HiPos+™ BOMT17 DIAMETER DEVIATION

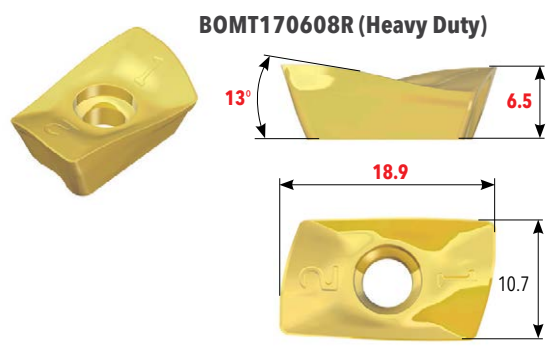
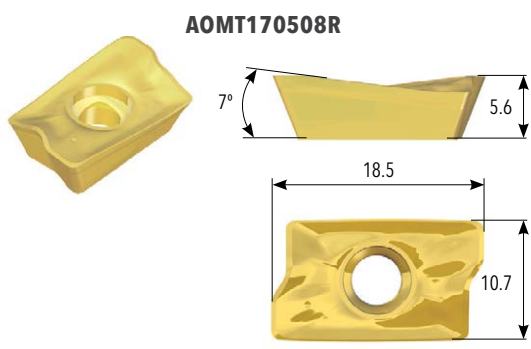
- Higher positive helix angle (AOMT17: 7°/ BOMT17: 13°) for smoother machining
- Thicker and stronger insert design (AOMT17: 5.6 mm / BOMT17: 6.5 mm)
- Compatible with the existing HiPos+ milling cutters for AOMT17

Please note possible cutter diameter deviations when using BOMT insert as follows:

Tool Diameter	Deviation of Diameter Compared to AOMT1705
.750" - 1.00"	+.004" ~ +.011"
1.25" - 2.50"	0
3.00" - 8.00"	-.004" ~ -.007"
